**NUMBER:** 18-035-04

Flash: MIL Illumination With Diagnostic Trouble Code P0339

2005 (PL) Neon

**Fig. 1 AUTHORIZED MODIFICATION LABEL**

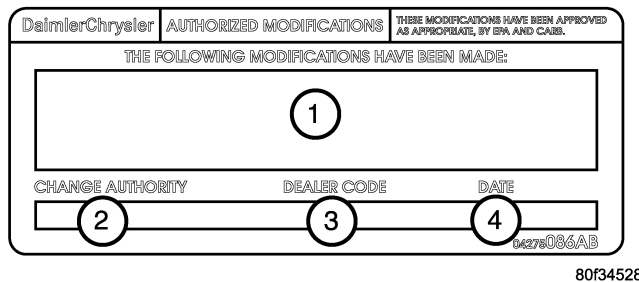
13. Type the necessary information on the "Authorized Modification Label" p/n 04275086AB and attach near the VECI label ([Fig. 1](#)).

- 1 - POWERTRAIN CONTROL MODULE P/N (INSERT P/N) USED
  - 2 - CHANGE AUTHORITY: TSB XX-XXX-XX
  - 3 - DEALER CODE: XXXXX
  - 4 - DATE: XX-XX-XX
-
